Docket Item #4
BAR CASE # 2017-00272

BAR Meeting
September 6, 2017

ISSUE: Alterations (Waiver of Rooftop Mechanical Screening Requirement)
APPLICANT: Jiraporn Achraruji
LOCATION: 105 North West Street
ZONE: CD/Commercial Downtown

HOUSE LOCATION SURVEY
LOT 24-B
MAP: #064.03-10-27
CITY OF ALEXANDRIA
VIRGINIA

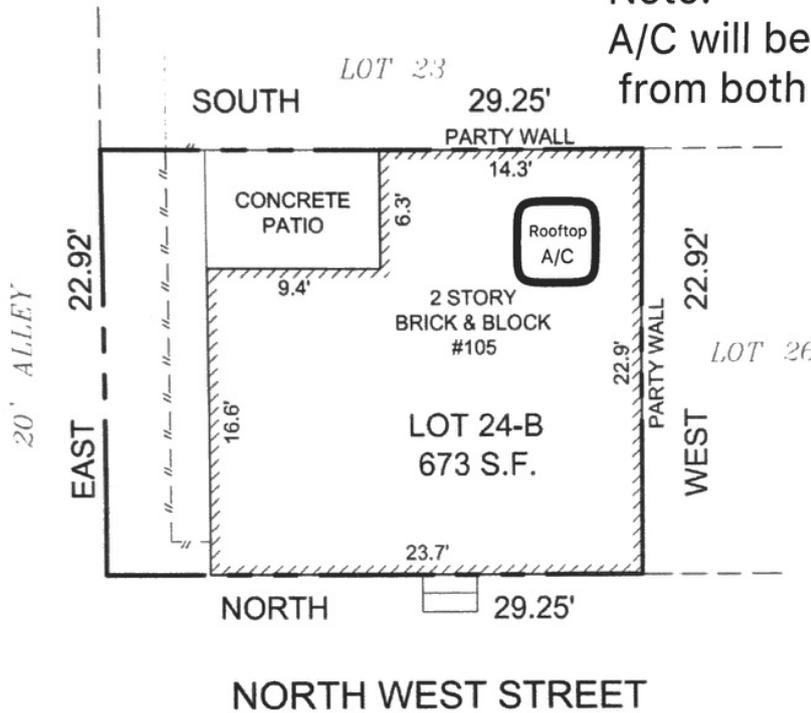
Note:
A/C will be placed 4' away
from both walls

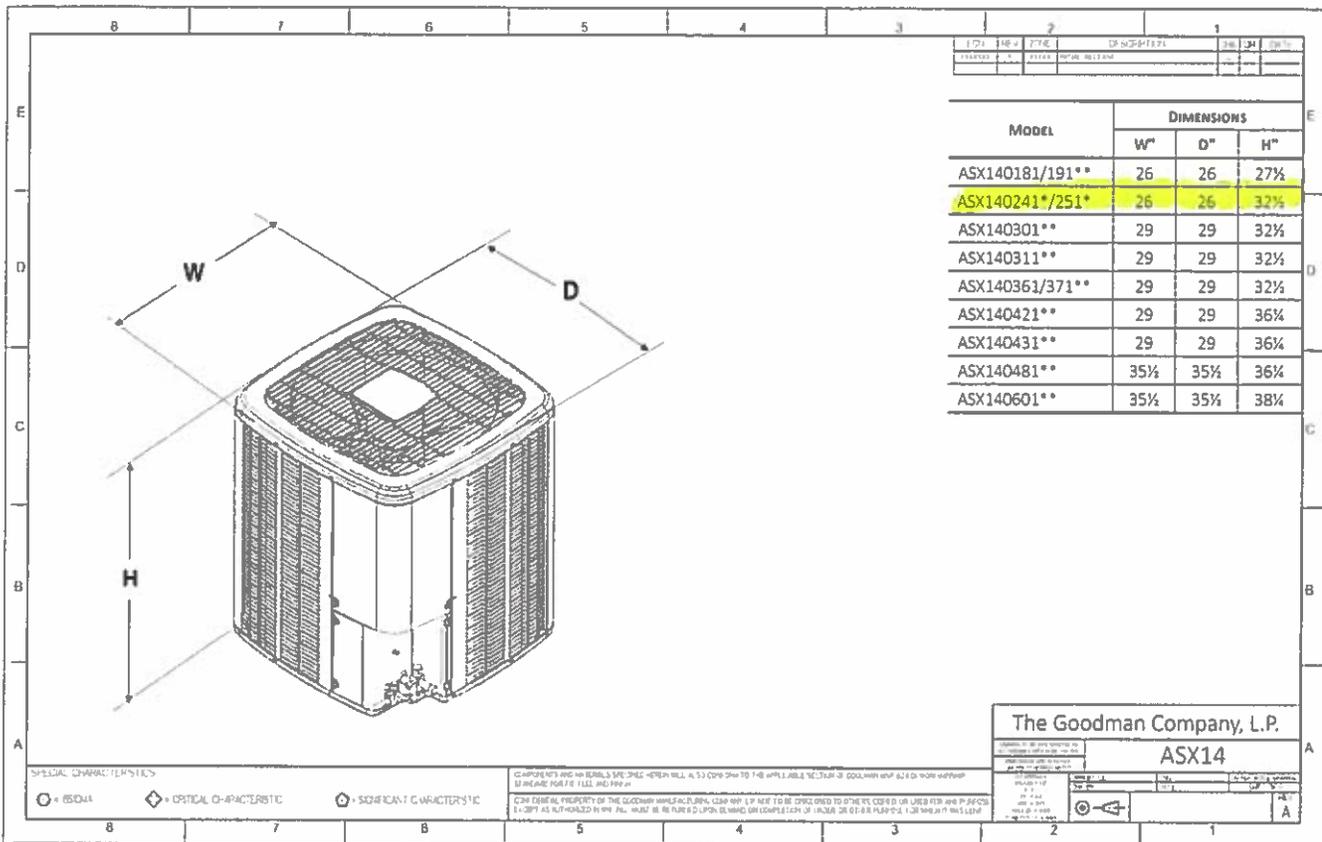
Staff recommends approval of the application to waive concealment of the rooftop mechanical equipment with the condition that the exterior case of the HVAC unit be painted the match the adjacent red brick wall color.

Staff believes that the unit has been sited on the roof in the best location possible in order to effectively minimize its visibility from a public way and recommends that the BAR waive the requirement for rooftop mechanical concealment, provided that the exterior case of the unit is painted the match the adjacent red brick wall color.
